35/13-05D 16 Newlands St
Chevy Chase Historic District

*approved by
HPC*

Staff Item
Anne Fothergill
September 10, 2008
16 Newlands Street

The HPC approved an addition to this house at 16 Newlands Street, Chevy Chase in 2005. The applicants submitted a landscape plan with fencing and walkways as part of that application. They would like to revise their landscape plan to show a change in their driveway material from asphalt to concrete. The dimension would remain the same as show on the attached plan.

LANDSCAPE PLAN

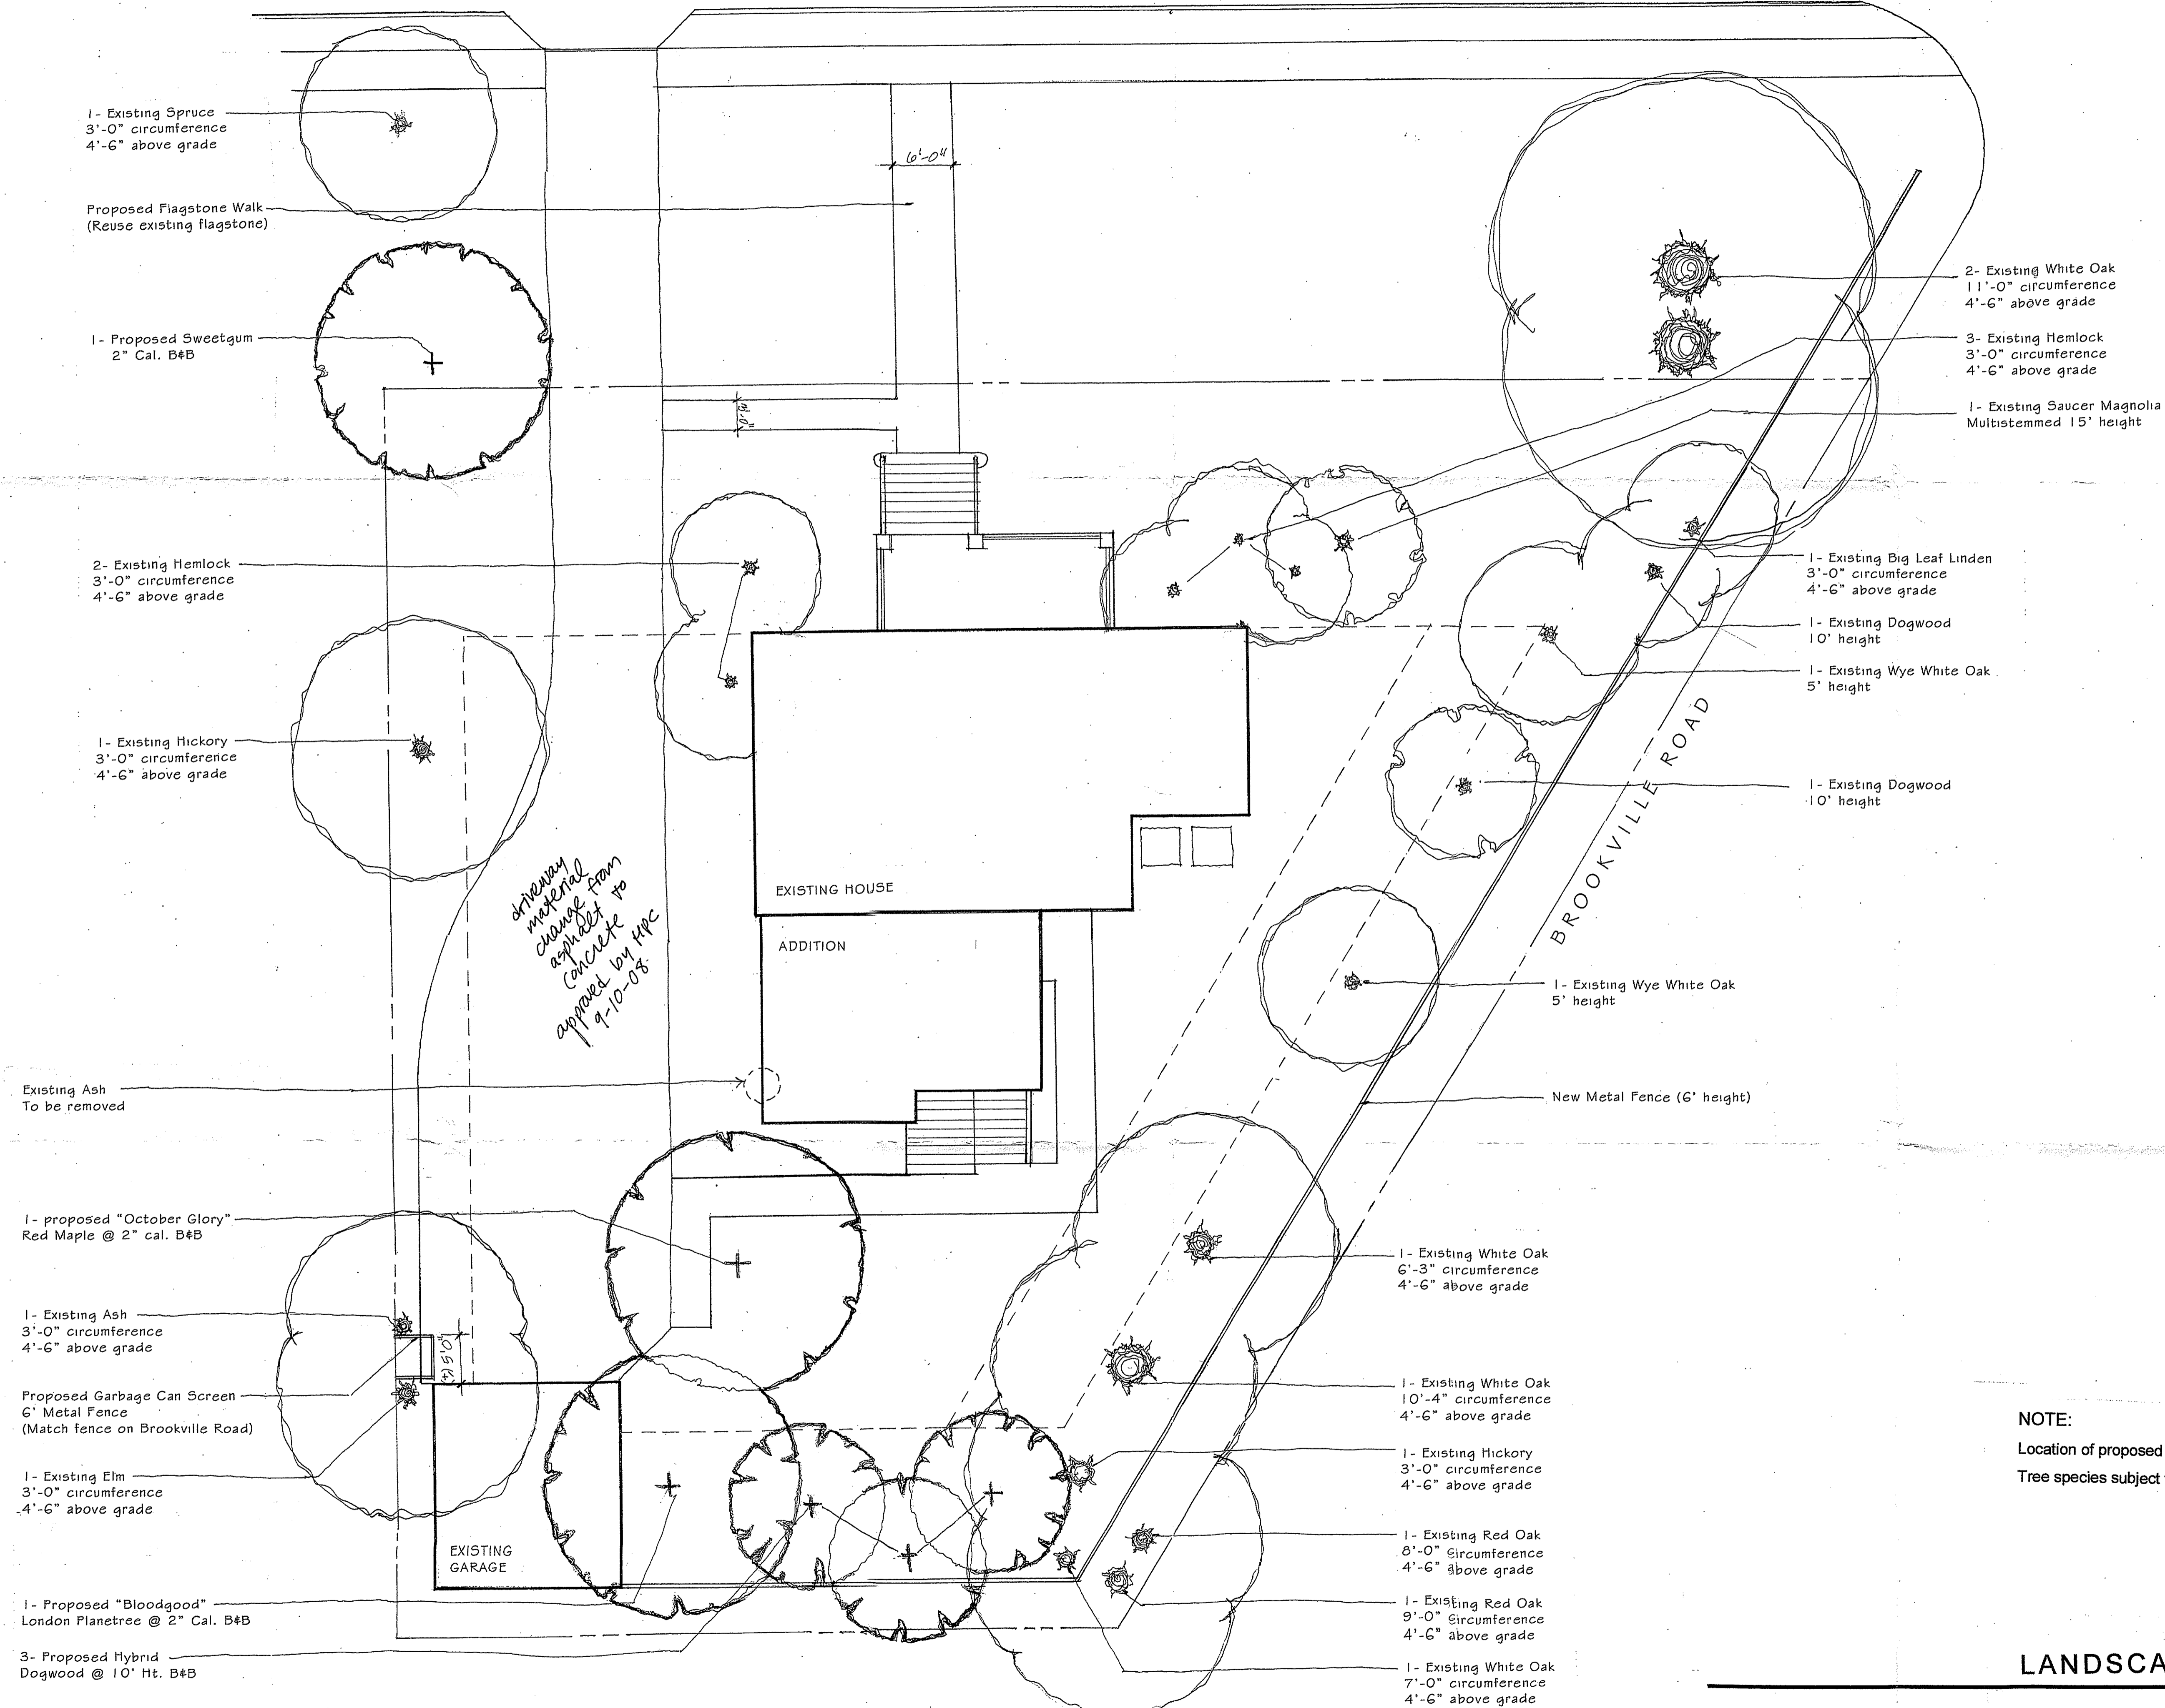
The stamped CORE plans we have (and the application plans in the files) show "existing driveway" and the Beth Wehrle landscape plan does not call out concrete so I don't think that plan will suffice for the Village's purposes. While the driveway shape change may be on the plans, I don't see any CORE plans showing a driveway material change to concrete. Do you have the stamped plans showing the driveway material change? If so, you could give those to the Village. The transcript from the August 2003 hearing, which is perhaps when the HPC discussed your driveway, is in Archives. None of the other transcripts that I see refer to changes to the driveway.

I will take this tonight to the HPC as a staff item and hopefully tomorrow I can write the change on the approved landscape plan and stamp it. It's possible that the HPC may require exposed aggregate concrete, I don't know what kind of concrete you had discussed in 2003.

Last night the Historic Preservation Commission approved the proposed driveway material change for 16 Newlands Street. The approval was for a change from asphalt to concrete with the design shown on the approved landscape plan dated July 12, 2005. Please go ahead and mark this approved change on the plan and hopefully this email will be sufficient for your processing of this permit.

VIEW FROM DRIVEWAY

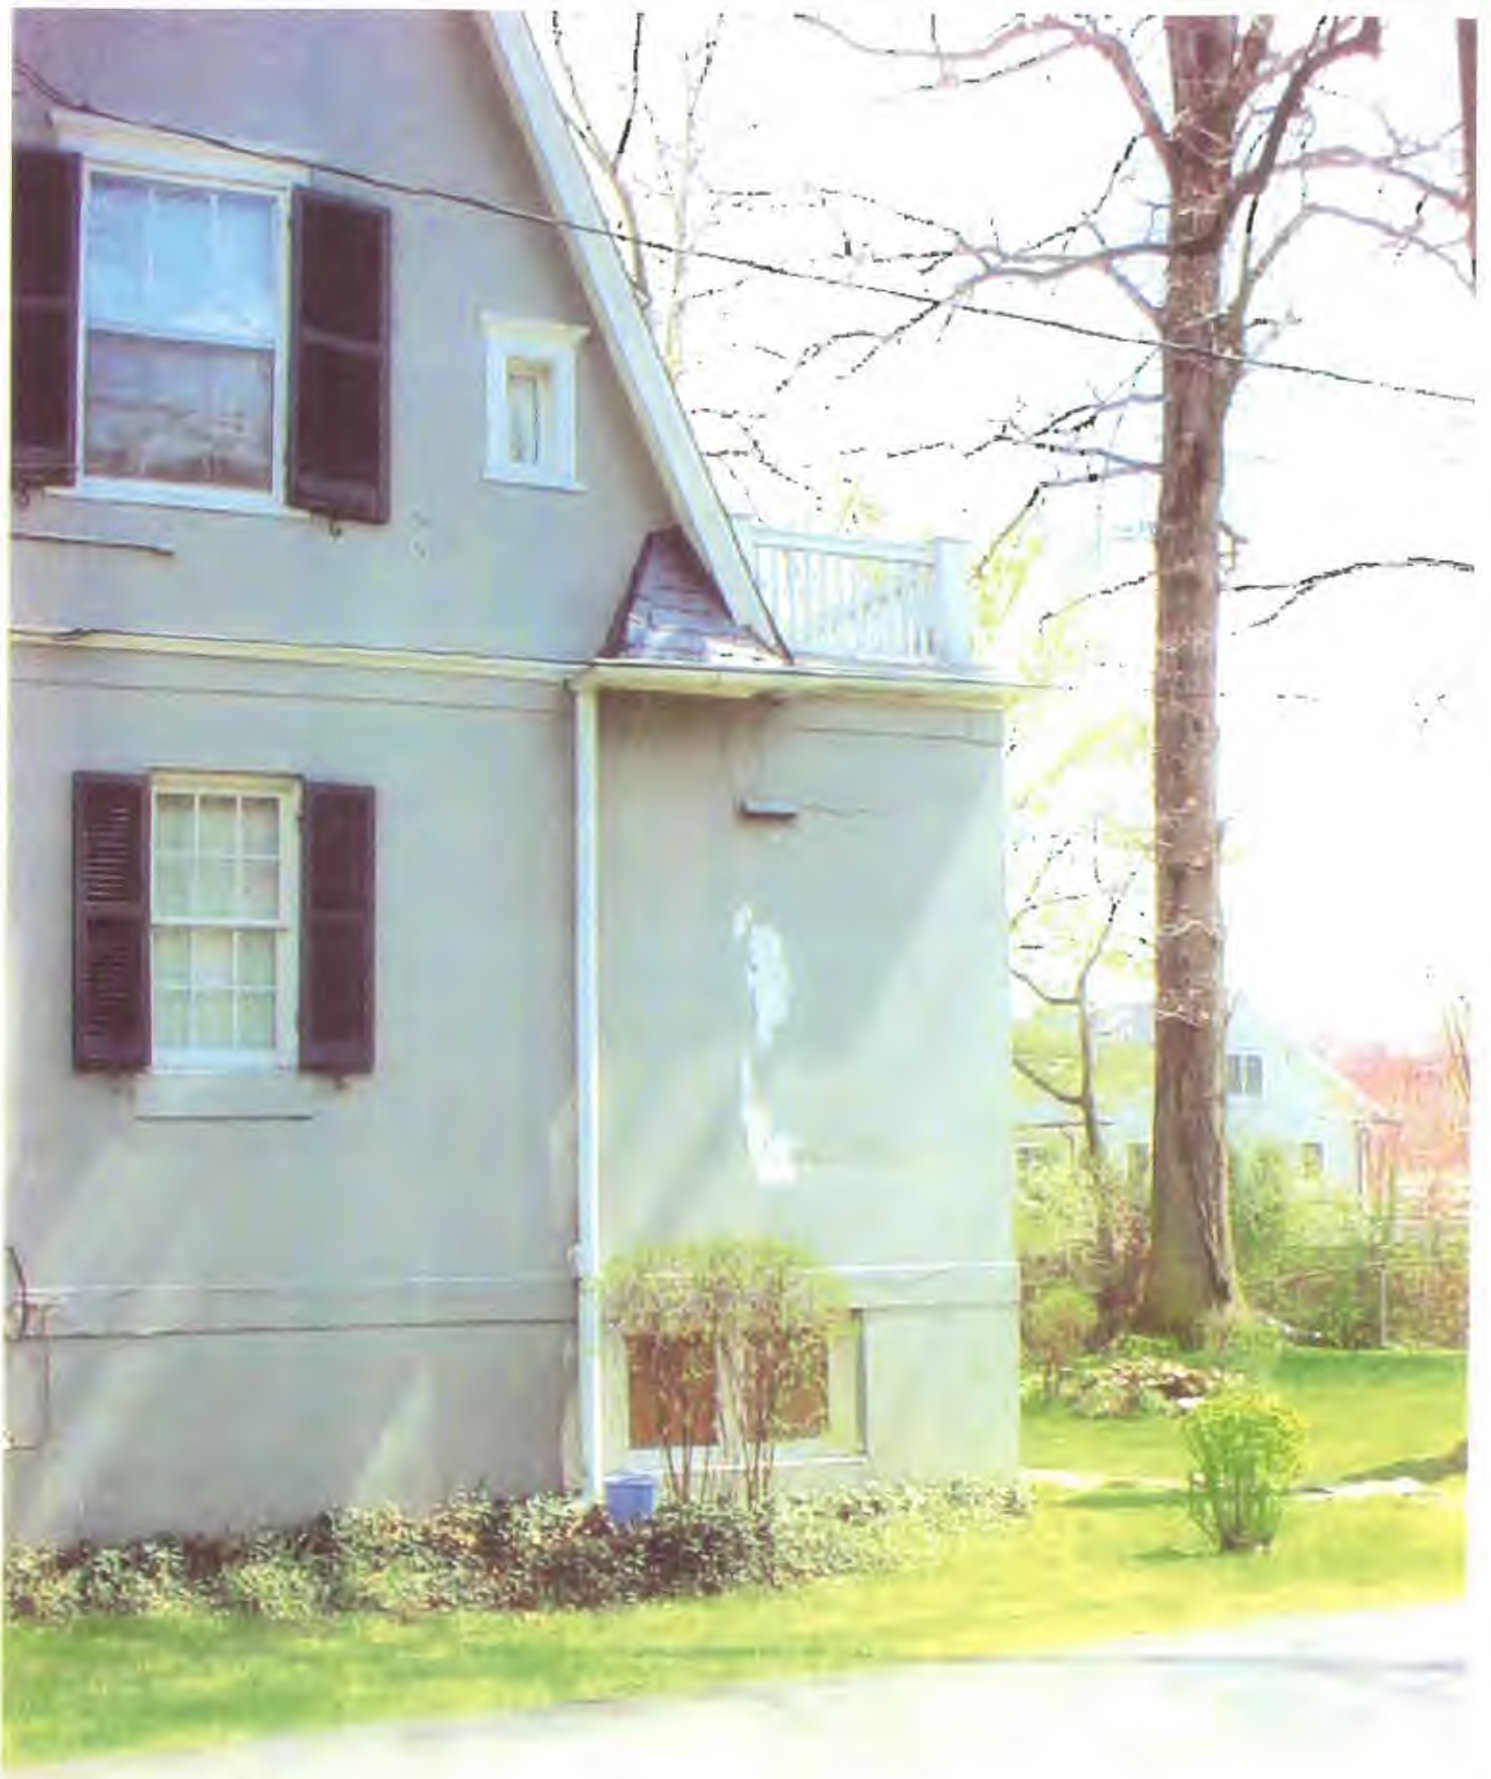
9 MR. FULLER: One thing that I guess I haven't paid
10 attention to, I was looking at the view from the driveway. The view
11 from the driveway, it read to me as if the new addition is set back
12 from the face of the existing house. But when I look at it in plan,
13 we're almost to the same line. And I think that concerns me a little
14 bit. I think I prefer to see some better separation there.

8 MS. WATKINS: And your view from the driveway, your really
9 haven't shown the stairs, the back stairs, and the stairs with the
10 railing, the detail around the -- is there a stair to the basement
11 there, it appears?
